State of New Mexico
Energy, Minerals and Natural Resources

SUNDRY NOTICES AND REPORTS ON WELLS
(DO NOT USE THIS FORM FOR PROPOSALS TO DRILL OR TO DEEPEN OR PLUG BACK TO A DIFFERENT RESERVOIR. USE "APPLICATION FOR PERMIT" (FORM C-101) FOR SUCH PROPOSALS.)

RKI respectfully requests permission to TA the Saragossa 17 State Com 3. Work will be suspended at the point where the necessary CIBP/cement plugs are set to prepare for cutting window and horizontal drilling while exploring the possibility of re-completing or plugging the subject well. The last recorded production was in May 2013.

Saragossa 17 State Com 3

PROPOSED

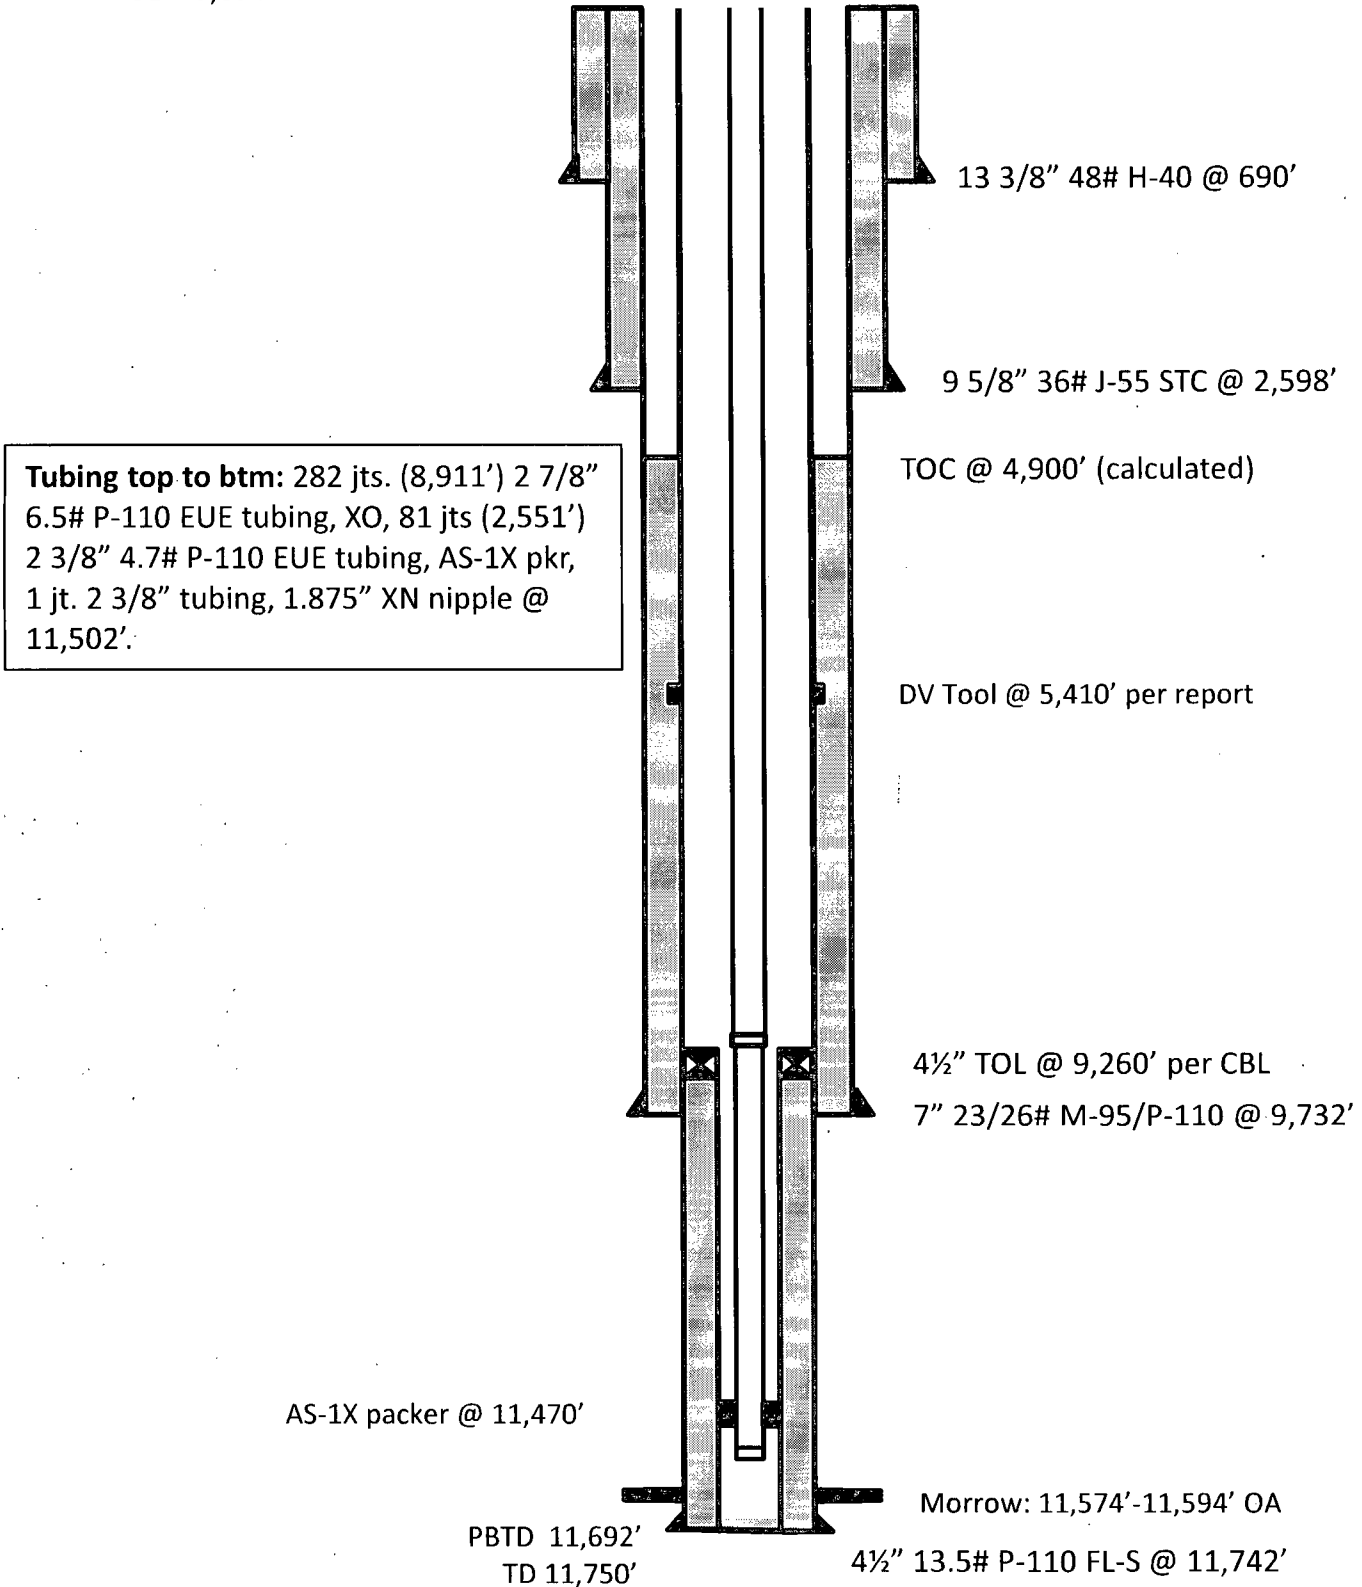
NOTE: ONLY BOTTOM CIBP REQUIRED. REST OF PLUGS NOT NECESSARY UNLESS YOU PLAN TO P&A WELL. IF SO - PLEASE RESUBMIT AS PLUGGING PROCEDURE. CONTACT OGD TO SCHEDULE MIT TEST.
